Access Compliance Report Public Rights-of-Way (Curb Ramps)

Intersection ID: N/A	Main Street: SANDY PORTER RD	Cross Street: SHUTTERFLY RD	Location: NE
ADA ID: E89DF4B47459	Ramp Type: Directional2	Initial Pass/Fail: Fail	Overall Compliance: No Severity Score: 1.25

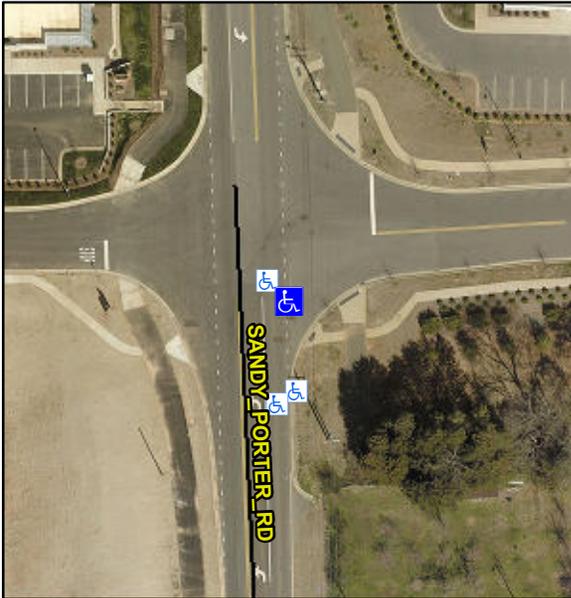
R304.5.3

Compliance	Description	Data	Compliance	Description	Data
N/A	Ramp Length (in)	142.0	N/A	Grade Break?	N/A
Yes	Ramp Width (in)	144.0	N/A	Grade Break Slope (%)	0.0
Yes	Ramp Slope (%)	5.7	N/A	Grade Break XSlope (%)	0.0
No	Ramp XSlope (%)	2.7			
N/A	Flare Type LT	N/A	N/A	Flare Type RT	N/A
N/A	Flare Slope LT (%)	N/A	N/A	Flare Slope RT (%)	0.0
N/A	Flare Traversable LT?	N/A	N/A	Flare Traversable RT?	N/A
N/A	Landing Length (in)	0.0	N/A	DWS Provided?	N/A
N/A	Landing Width (in)	0.0	N/A	DWS Contrast?	N/A
N/A	Landing Slope (%)	0.0	N/A	DWS Length (in)	N/A
N/A	Landing X Slope (%)	0.0	N/A	DWS Full Width?	N/A
N/A	Landing Curb? (Y/N)	N/A	N/A	DWS Offset LT (in)	N/A
N/A	Shared Landing?	N/A	N/A	DWS Offset RT (in)	N/A
N/A	Gutter Ponding?	0.0	N/A	Gutter Slope (%)	N/A
N/A	Gutter Lip Ht (in)	0.0	N/A	Gutter X Slope (%)	N/A
N/A	Painted X Walk1?	No		Road Slope (%)	0.7
	X Walk 1 Direction	To SE		Road X Slope (%)	4.2
	X Walk 1 Width (in)	N/A		Clear Space?	N/A

Remove & Replace Entire Ramp.
